70 Oakley Square London NW1 1NJ

70 Oakley Square – London NW11NJ - Application 2012/3339/P

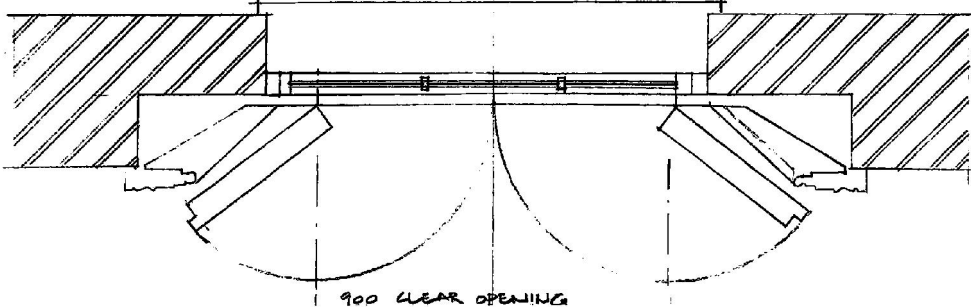
This device is not a new idea and I enclose by way of illustration an example from Ditchley, which demonstrates how the integrity of the window is retained. There are probably others but I have not had an opportunity to source them yet.

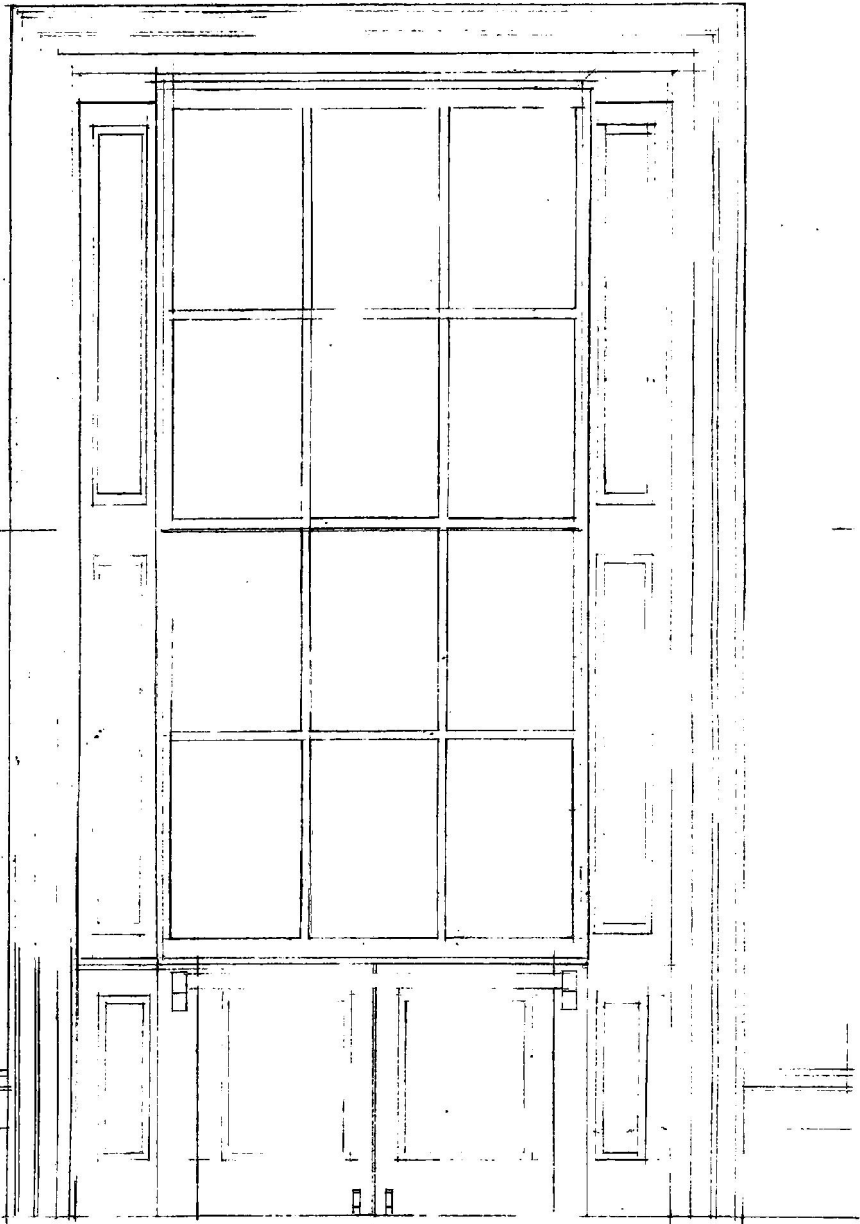
Please refer to the enclosed sketch drawing; in principle the proposal is to retain the sash window and introduce an opening timber panel under the window so it is possible to pass from the kitchen to the balcony. The clear underside of the upper sash is 1750mm above floor level, which would provide enough headroom for most people to pass under cleanly, and with taller individuals a slight dip of the head would be required, but egress is still relatively easy for most people.

The concrete cill and timber cill of the window are not original (these have been previously renewed) and these would be removed and a new cill formed into the top of the opening timber panel. The only piece of historic material removed would be a small section of brickwork.
